TOWN OF  
EAST MONTPELIER, VERMONT  
SELECTBOARD

Re: East Montpelier Access Permit #19-015

## ACCESS (CURB CUT) APPLICATION

# Wallstrom Lot -- Factory Street

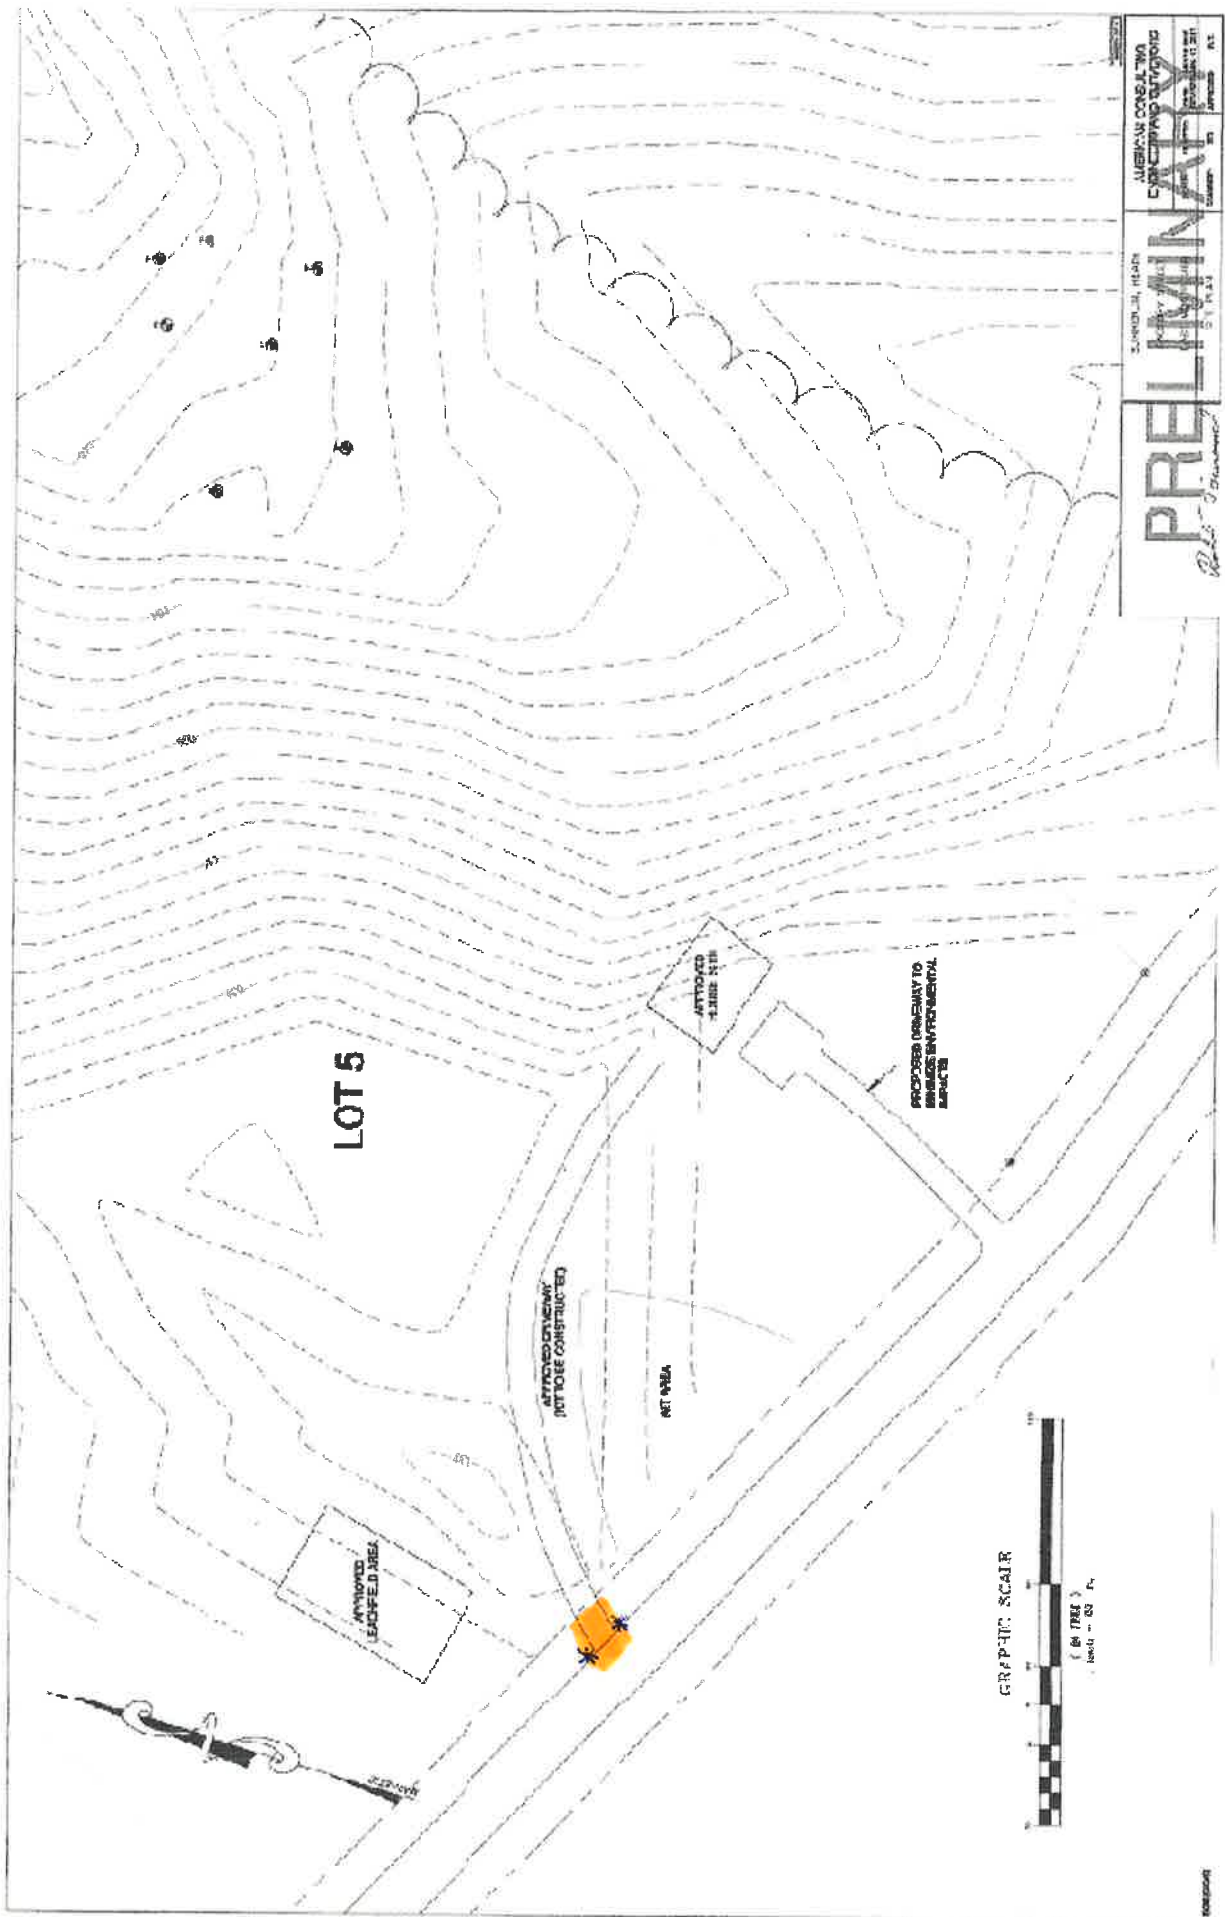
☒ Proposed access meets applicable sight distance standards. Comments: Brush clearing necessary for adequate sight lines.

30' minimum 15" drive culvert.  
Discontinue use of and leave as is the existing  
curb cut.
